147 Major St — HVAC clash mark-up

HVAC Designs LO# 113963 (HVA 26 167838) vs permit 26 167838 BLD 00 · PalmView BIM review · Oct 22, 2026

Two systems: F-1 basement (basement + main floor from below) · F-2 2nd-floor mech room (2nd + 3rd floors from the 3rd-floor joist space).

Sheet Title
BASEMENT HEATING LAYOUT

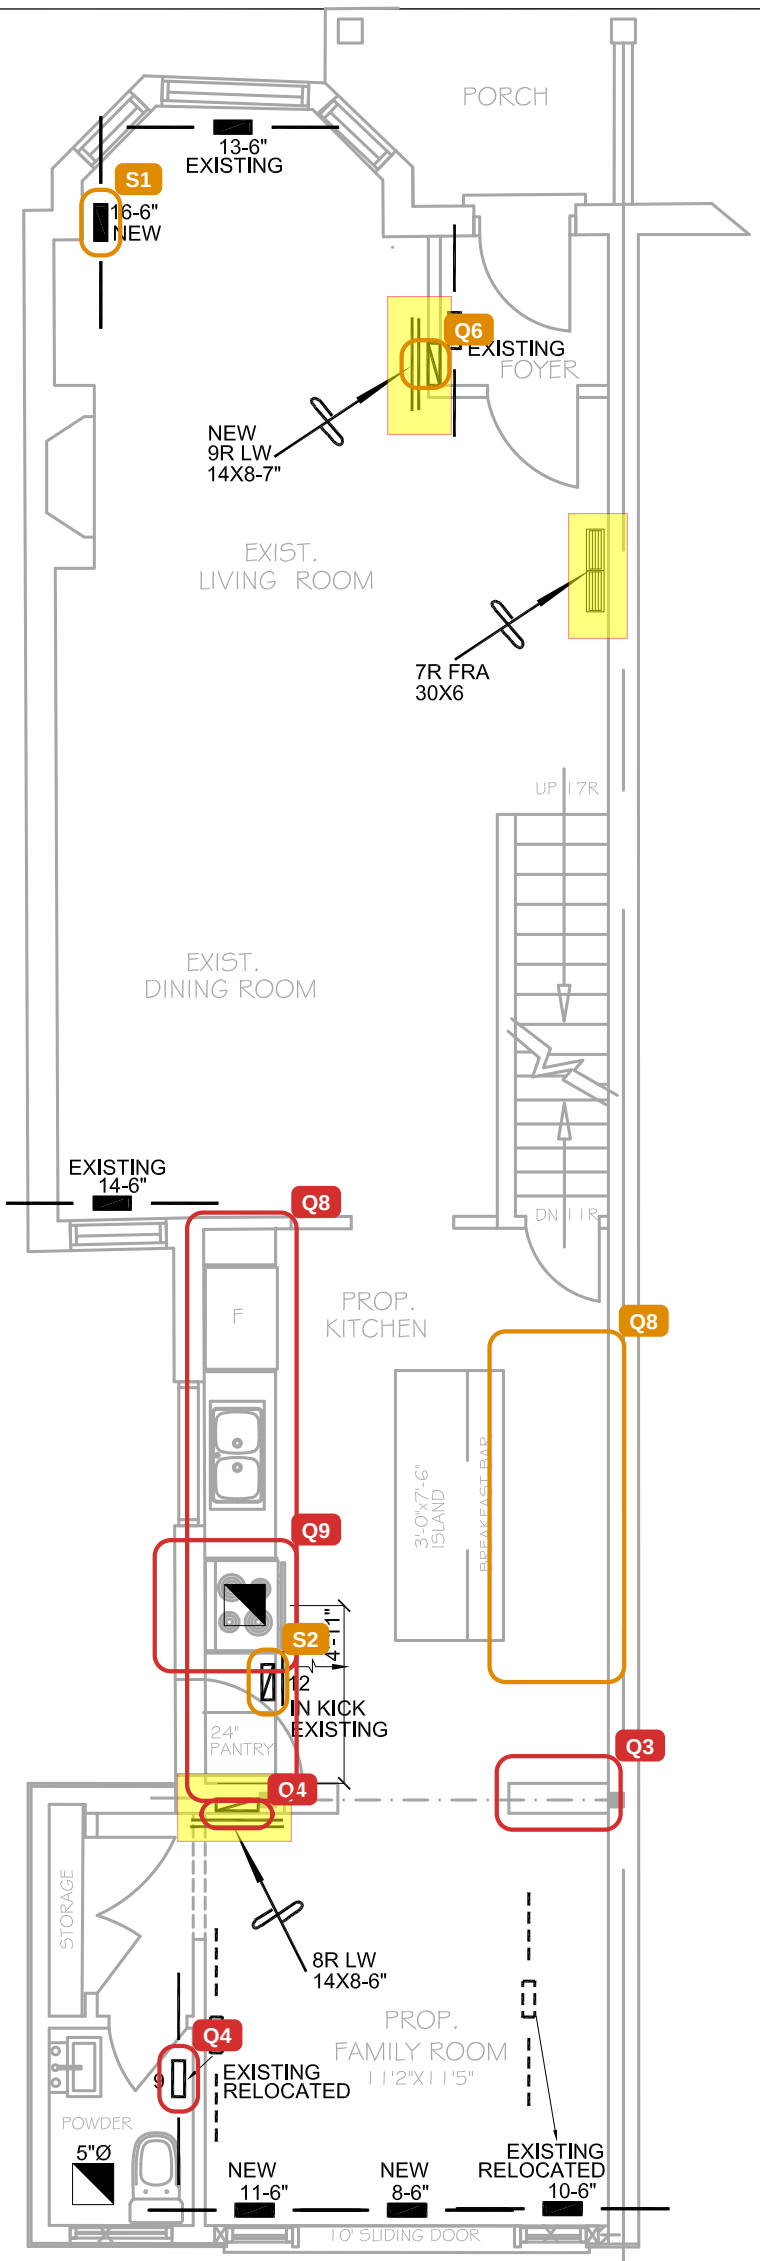
Core three holes in the brick, or route all rear branches through the existing 30" opening. Owner: HVAC sub. Status: OPEN.

Both stacks land on top of existing masonry (powder E wall, pantry/storage double wall). Relocate. Owner: HVAC Designs. Status: OPEN.

All stick out 3–4" past the studs. 3-1/4x14 stacks, 2x6 walls, or chases. Owner: HVAC sub / framer. Status: OPEN.

F-1 not tagged existing and sits where the permit shows the existing H.E. furnace. Takeoff runs over the tank vent. Owner: PalmView. Status: OPEN.

Q3 Rear branches 8, 10, 23 through the old rear foundation

Q4 Supply 9 and return 8R sit on old foundation walls

Q6 7" return stacks in 2x4 walls (1R–6R, 9R) and 6" supply stacks

Q10 F-1 new or existing; hot water tank vs plenum

S3 Trunk E ends ½" off the old rear wall

Sheet Title
FIRST FLOOR HEATING LAYOUT

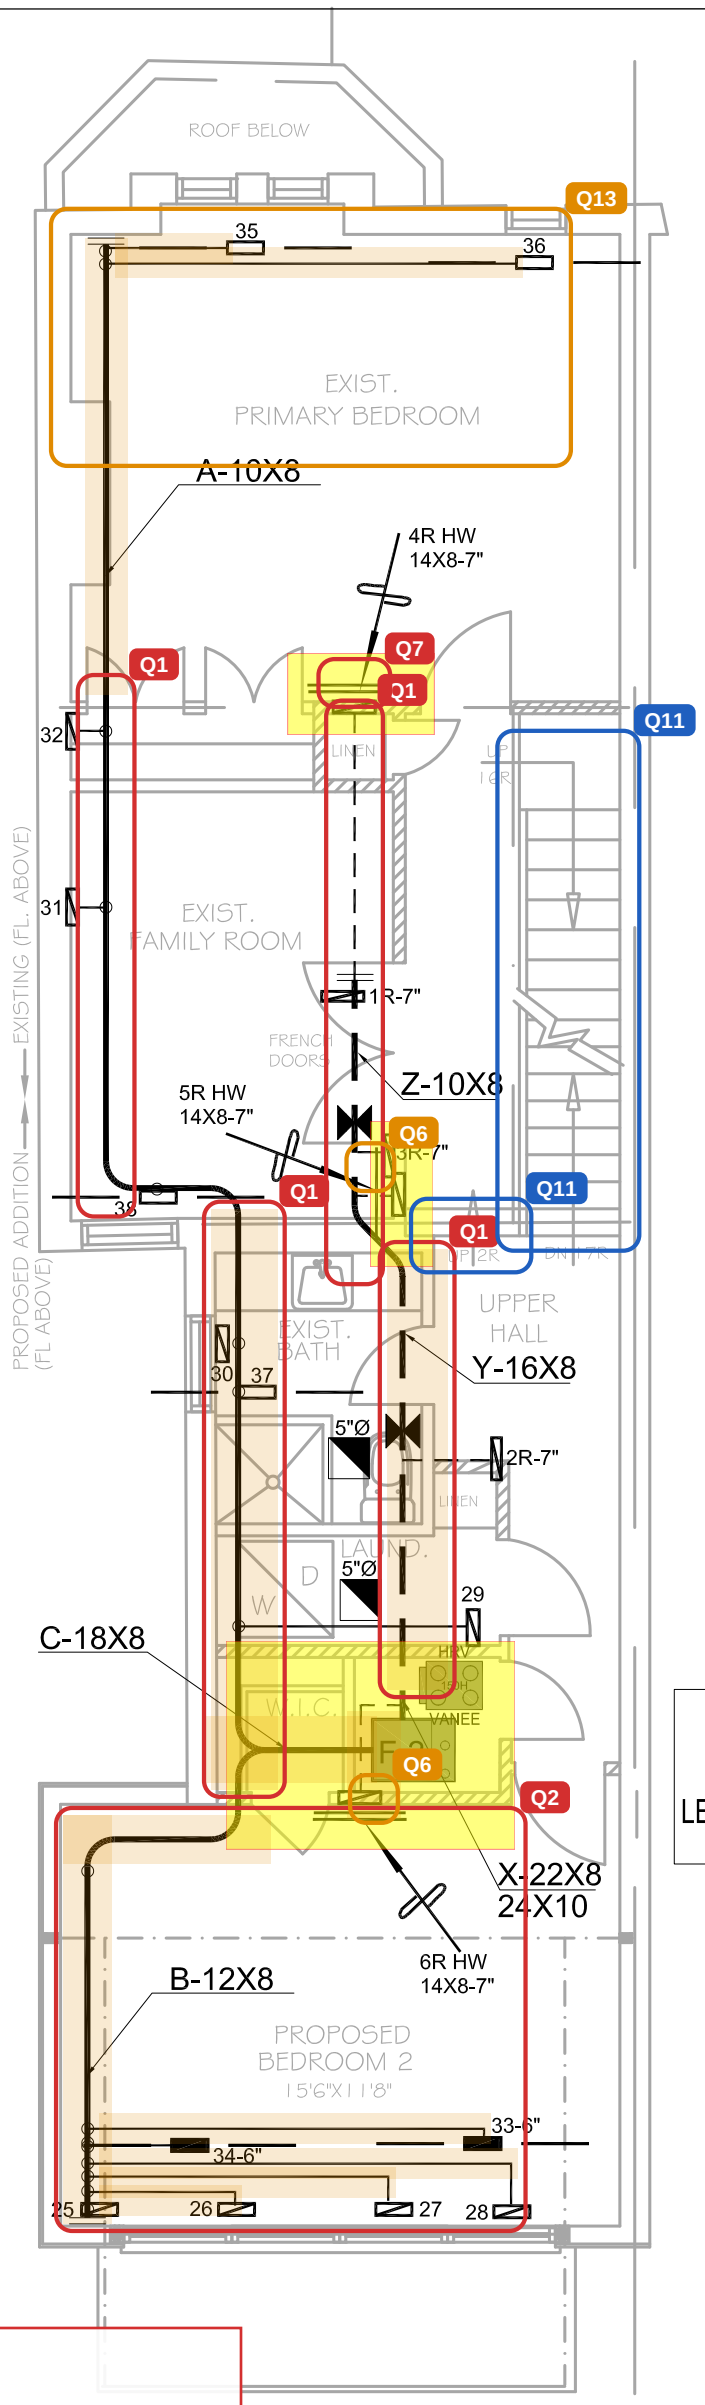
Permit shows a 30" range and 34" fridge; Miele range and fridge are 36". Cabinet set 186.5" vs 184.6" wall. Aisle to the stair is 34.9". Owner: Cabinet shop / PalmView. Status: OPEN.

Elica Trento insert on the south wing wall under the 2nd-floor overhang. No duct or termination drawn. Owner: HVAC Designs. Status: OPEN.

- Q3 Rear branches 8, 10, 23 through the old rear foundation
- Q4 Supply 9 and return 8R sit on old foundation walls
- Q6 7" return stacks in 2x4 walls (1R–6R, 9R) and 6" supply stacks
- Q8 Kitchen sizes: range, fridge, run length and aisle
- Q9 Kitchen hood exhaust not designed
- S1 Supply 16 boot tight to the bay corner
- S2 Supply 12 kick register under the pantry

Sheet Title
SECOND FLOOR HEATING LAYOUT

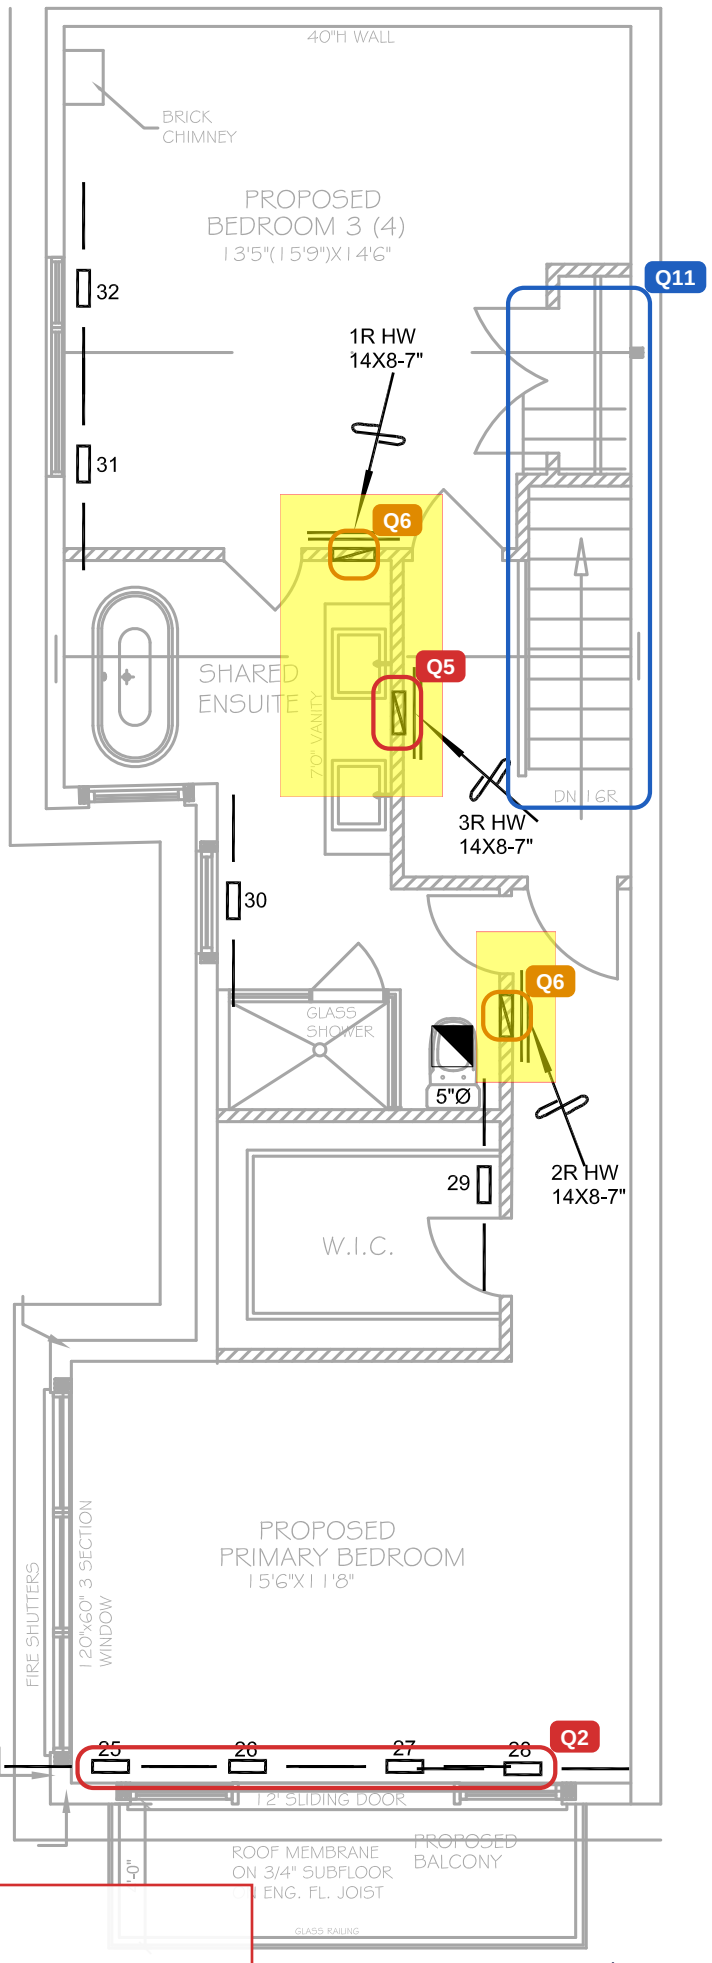
Rear (lower) level, 10'-4½" ceiling: drop the hall / bath / laundry / W.I.C. / bedroom 2 ceilings flat to ~9'-6" to hide C, B, Y, 6R and branches 25-28, 33/34 (or box them at 9'-8"). Front (upper) level, 9'-0½" ceiling: trunk A along the south wall and return Z in the family room need 14" bulkheads at 8'-4", or a reroute. Owner: PalmView / client. Status: RESOLVED.

Confirm the cantilever TJIs over bedroom 2 run front-to-back (balcony). Trunk B sits on the south LVL1; 5 branches cross 26 cantilever joists. Owner: Kott / Rona + engineer. Status: SITE.

Grille is on the closet wall right under LVL5; the stack cannot pass the beam. Owner: HVAC Designs / engineer. Status: RESOLVED.

Plans A8/A9: new stair stacked over the existing one, rising front-to-rear. Section A-A draws it rising rear-to-front. Step: section A-A framing shows 16" (2R at 8"); the rear and south elevations show 1'-9" (10'-11" vs 9'-2"). Model uses 16". Owner: PalmView / designer. Status: OPEN.

Trunk A (first 6.7 ft) and branches 35/36 are under the existing front roof. If that space is outside the insulation, ducts need R-12 + Class A sealing (permit note). Owner: PalmView. Status: OPEN.

Q1 2nd-floor ceilings for the F-2 trunks

Q2 Bedroom 2 ceiling: joist direction and trunk B on LVL1

Q6 7" return stacks in 2x4 walls (1R–6R, 9R) and 6" supply stacks

Q7 Return 4R stack vs the LVL5 flush beam

Q11 Stair direction 2nd → 3rd, and the size of the 2nd-floor step

Q13 Front roof space over the primary bedroom

Hung under the joists, three runs moved off wall top plates: trunk C 2" east (was 1.4" into the notch wall), return Y 5" east (was over the bath east wall), 6R run and stack 5" east (was over the W.I.C./mech wall). Still to place on site: the C-to-A tie (10x8 at the step line) lands between the family-room rear wall and the bath north wall, which are only 7.8" apart - box it on the family-room side.
